ADDENDUM No. 1

RFP No. 22-15

Stadium / Washtenaw Area Utility Improvements

FRIEZE AVENUE PAVEMENT SECTION
N.T.S.

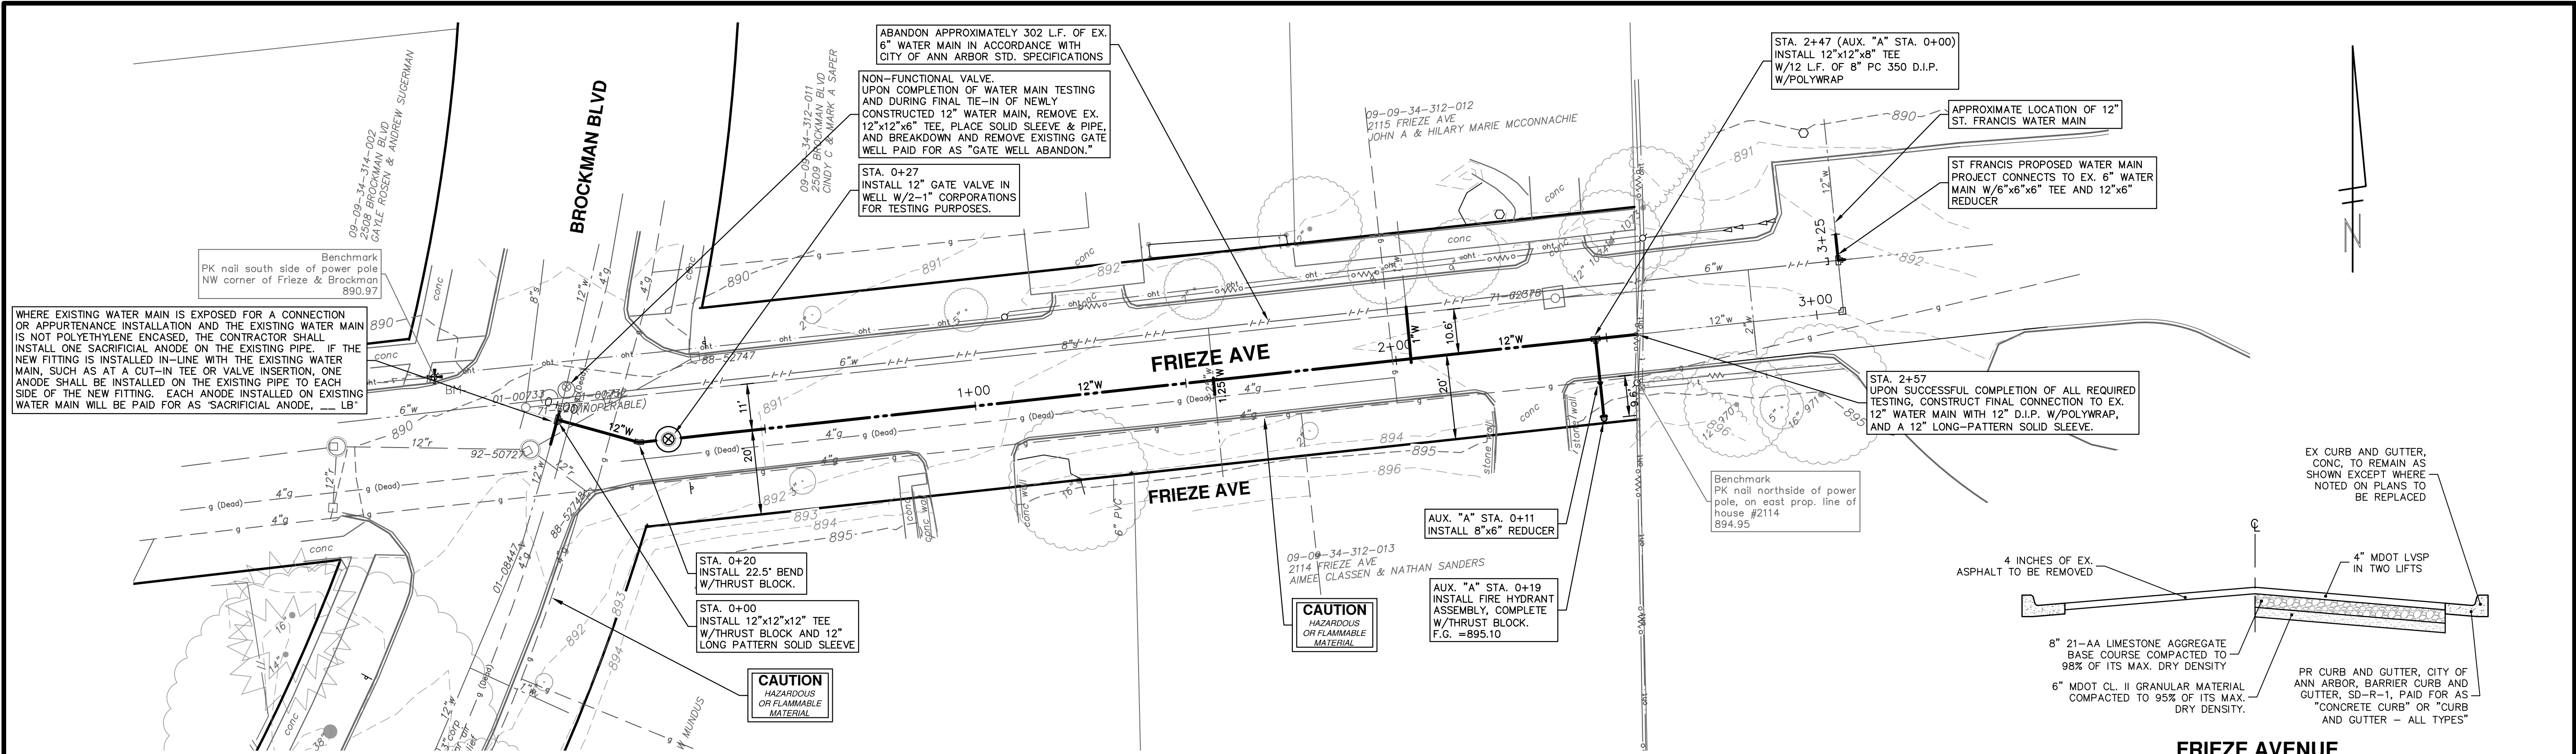
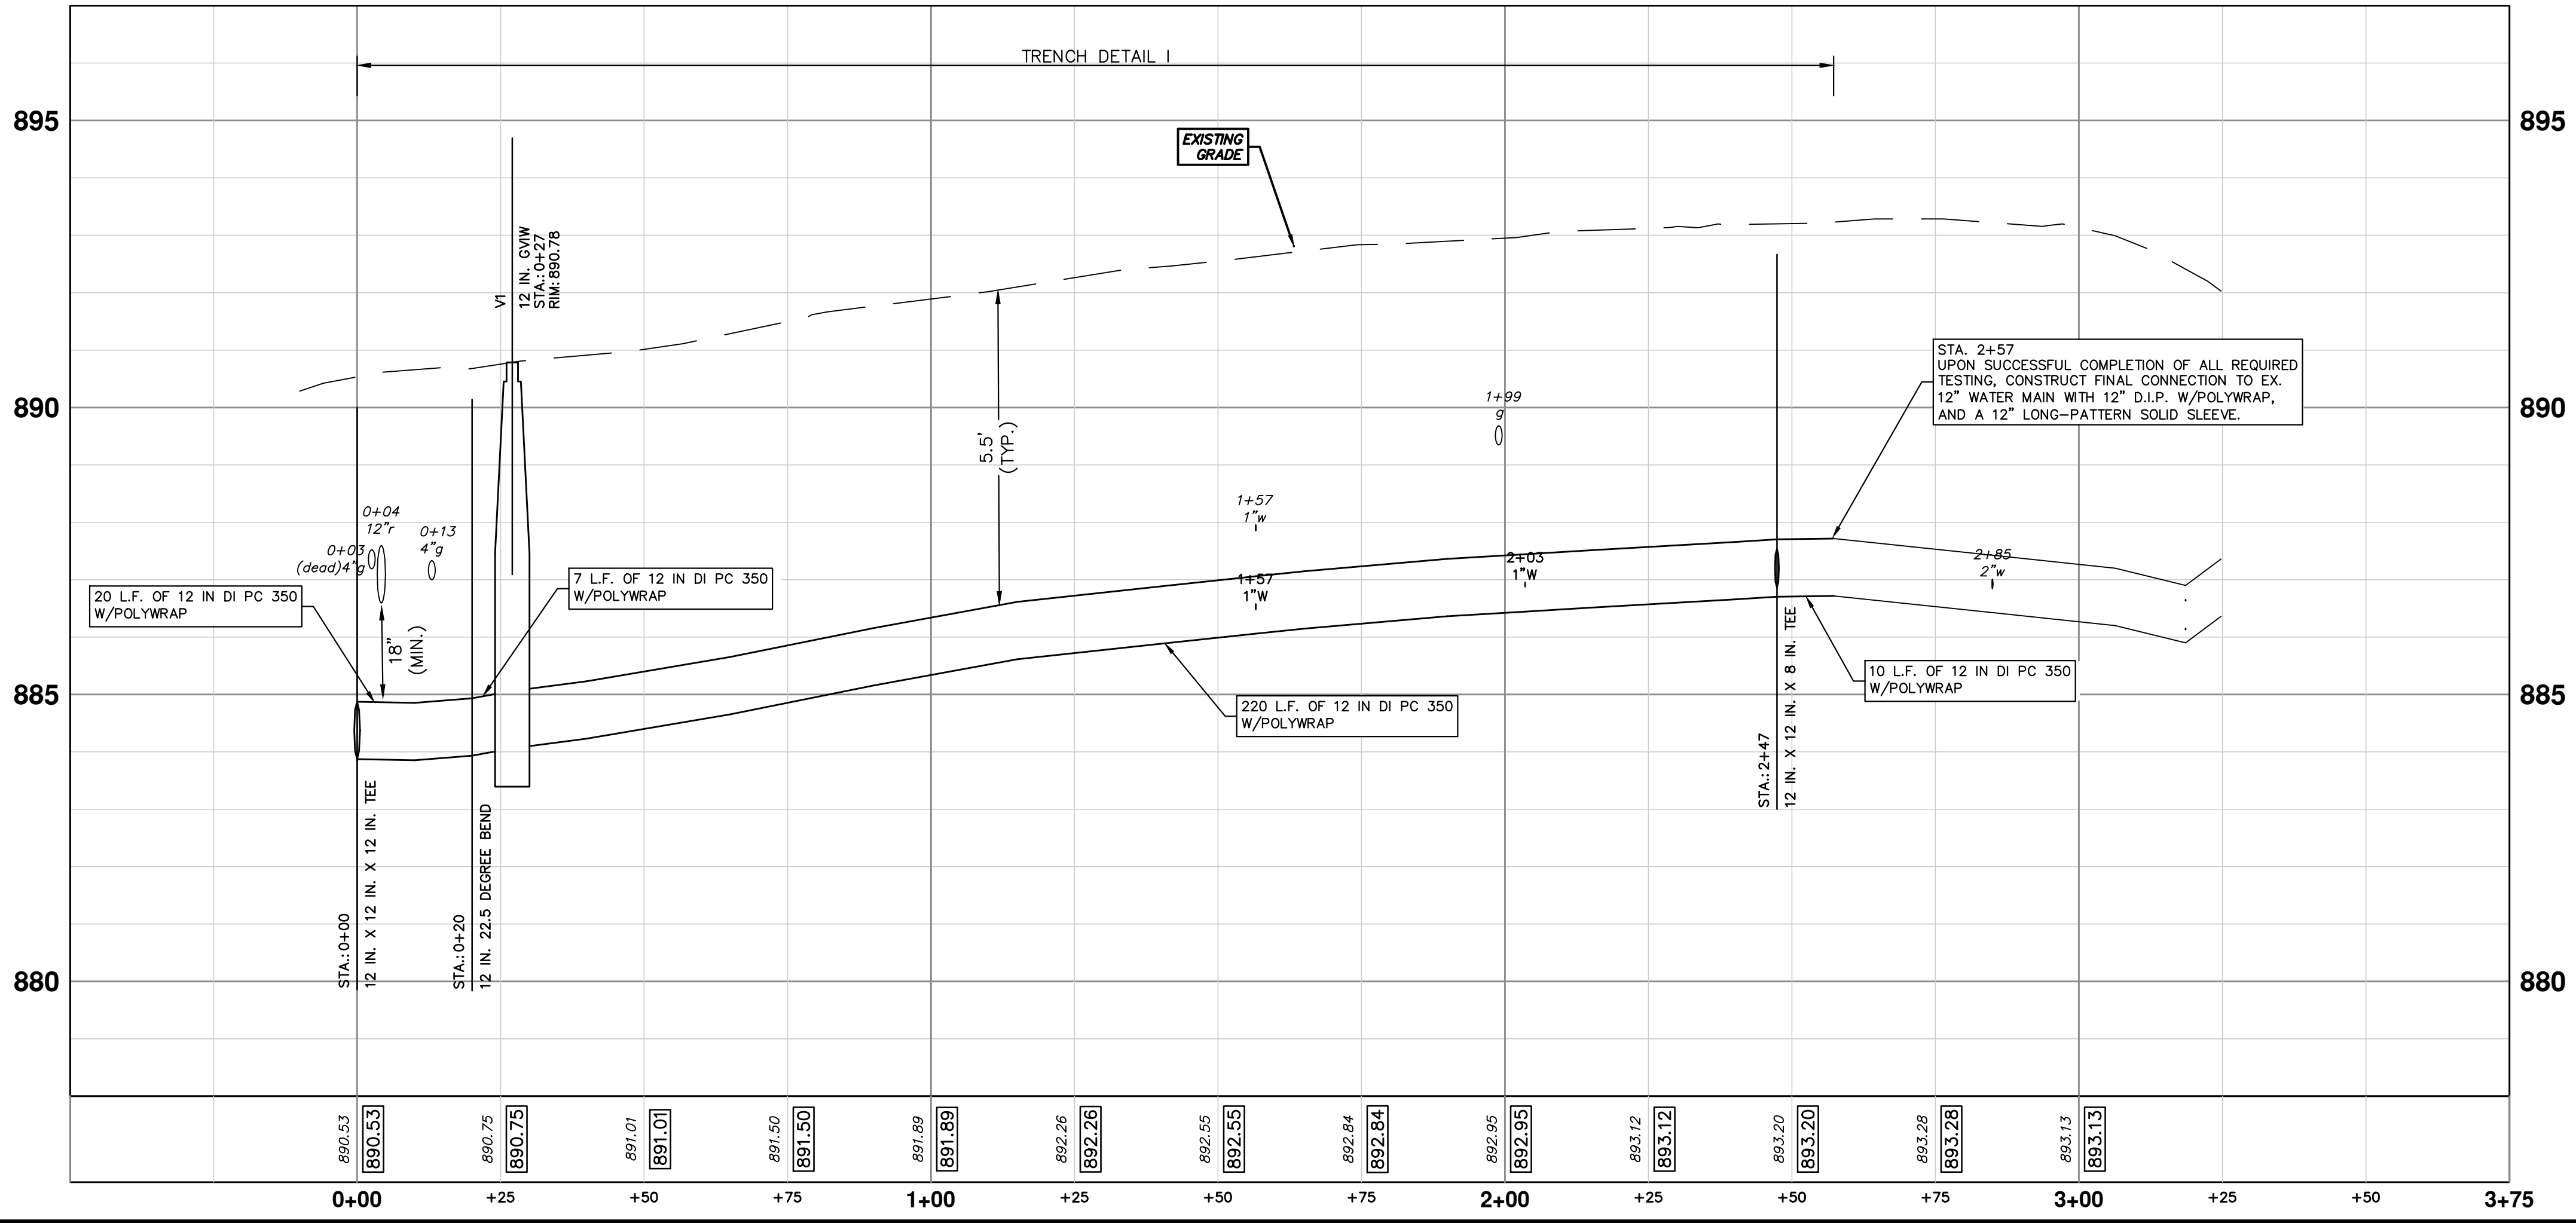
- Question 10: Is the intent for grading Frieze/Winchell/Brockman to regrade the roads? You have cross sections for the sidewalks that are to be installed but there are no grading plans for the road itself?

- Answer 10: The project, other than the utility and sidewalk construction, is primarily a resurfacing project. The intent is to resurface the remaining areas of the streets that are not disturbed by sidewalk grading, watermain, water tie-ins or storm sewer construction. See revised plan set including proposed cross sections.

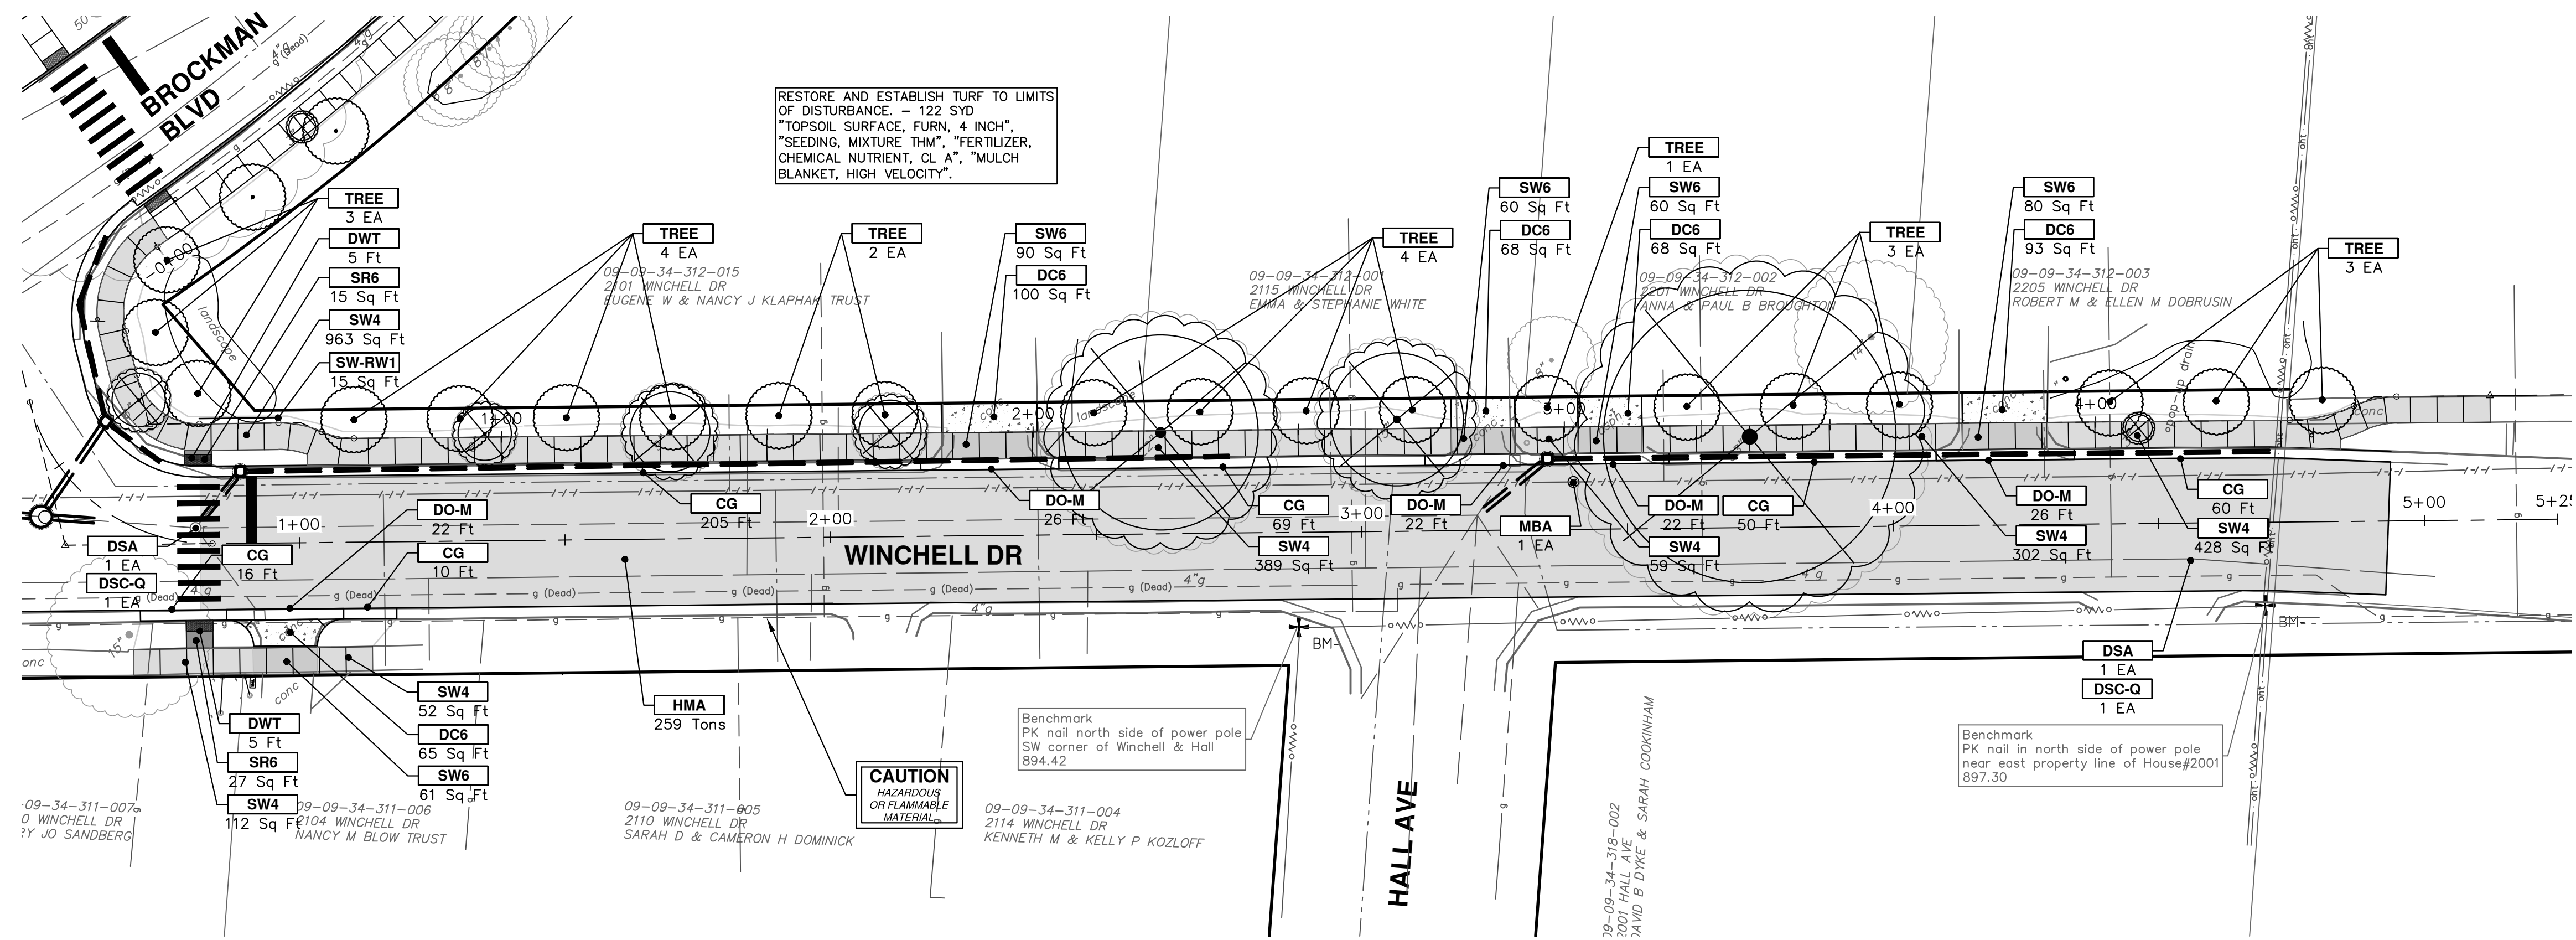
- Question 11: On page 34 in the plans, you show a bunch of tie-ins in Winchell Dr. with associated removals. However, in the removal plans, you show removing the entire street. Are you just wanting us to do these tie-ins when we do the storm on Winchell Dr? The only area that is not within the road removal area is in the bottom right of sheet 34.

Answer 11: The water transfers and storm work may be done at the same time. The tie-ins and storm trenches are to be restored full depth per the section and then resurface the remaining pavement.
